## CSP Site Visit and Hearings w/c 4<sup>th</sup> December 2023.

## Cottam OFH2

## Cottam Solar Project CAH 7<sup>th</sup> December

### **Below. Figure 15.9: Sensitive Receptor Location Plan from the June PEIR document.**

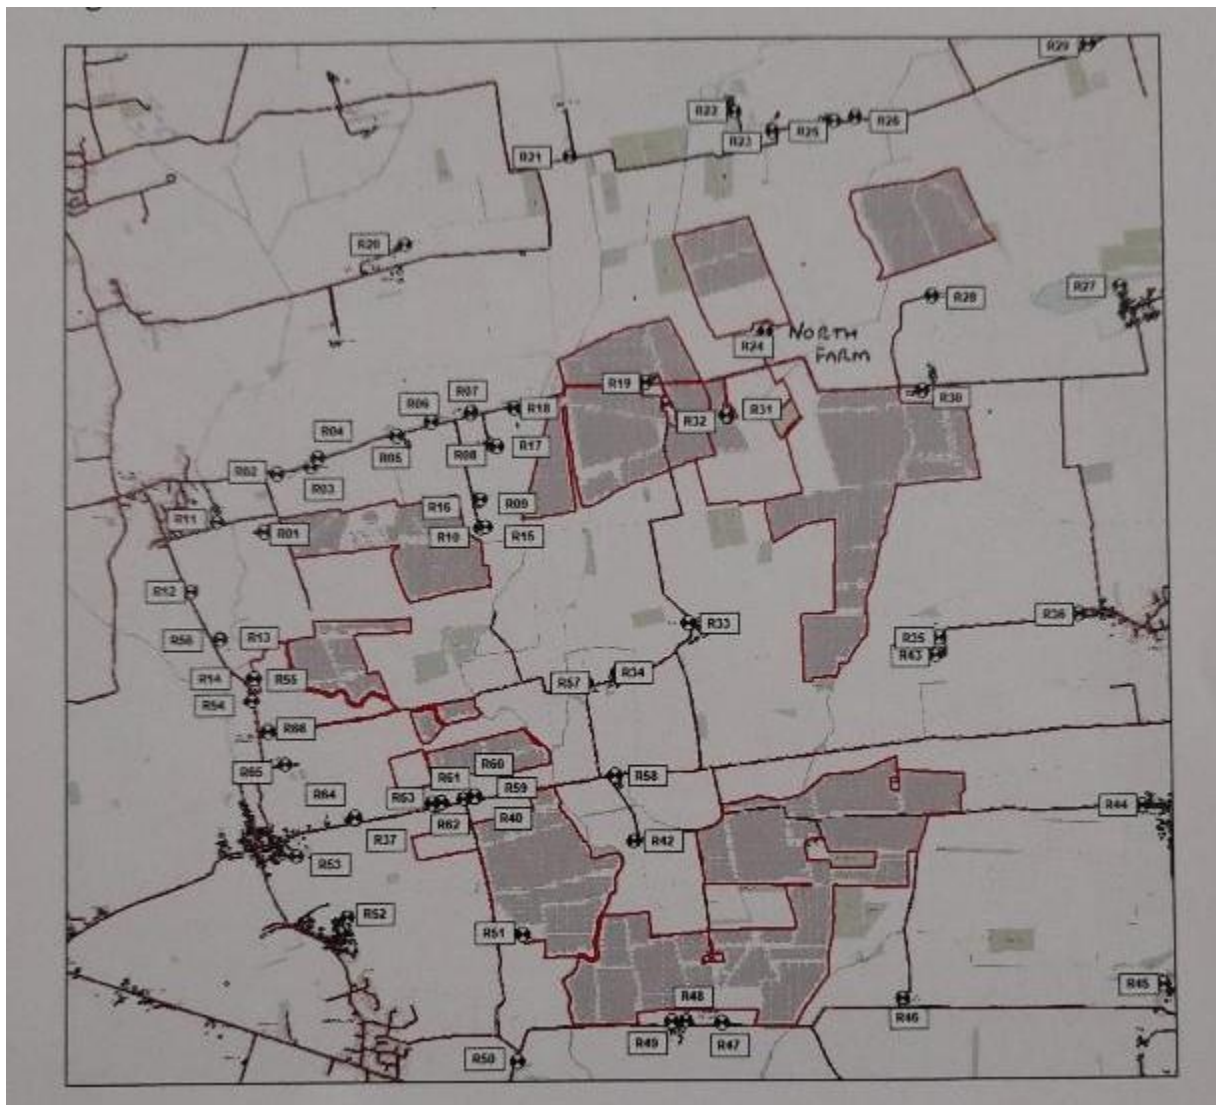
What this map also shows are areas of solar panel exclusion as agreed during consultation and considers our home (R24) equally with other isolated properties in the area, such as Fillingham Grange to the East (R28) and Low Farm to the Southeast (R35 & R43). However, this is not reflected in the final plan!

Above, Figure 15.9: Sensitive Receptor Location Plan from the June PEIR document.

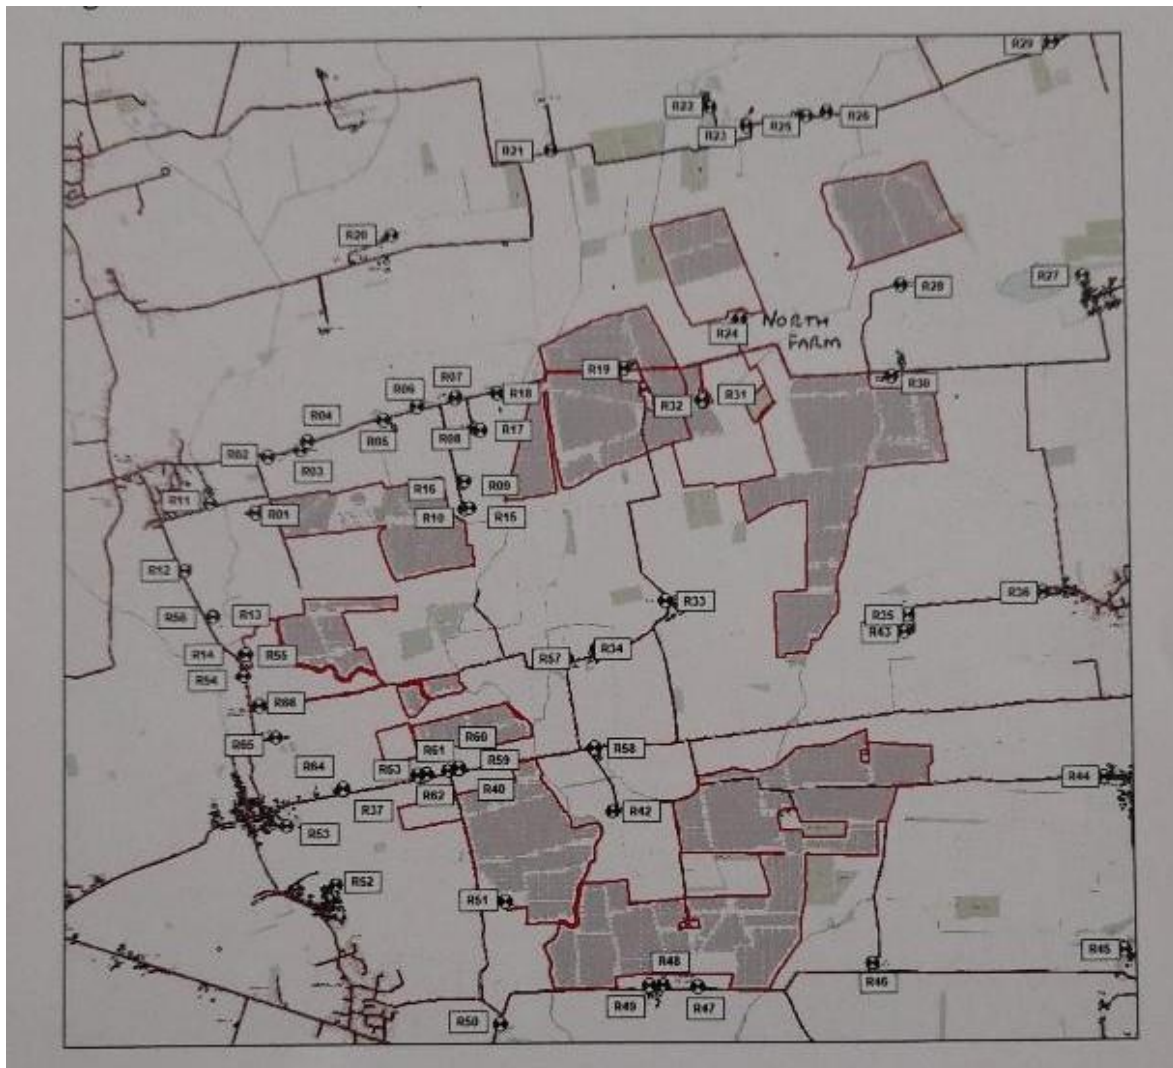
**Respectfully Sir, all I ask is that our home is protected as originally agreed during consultation and as indicated on the map below."**

**What this map also shows is the areas where the solar panels to the North and South should have been removed as agreed during consultation and considers our home (R24) fairly with other isolated properties in the area.**

**This is not reflected in the final plans.**

**Our home would be the worst affected private property on this scheme. The farming estate properties have far better exclusion/buffers than us.**
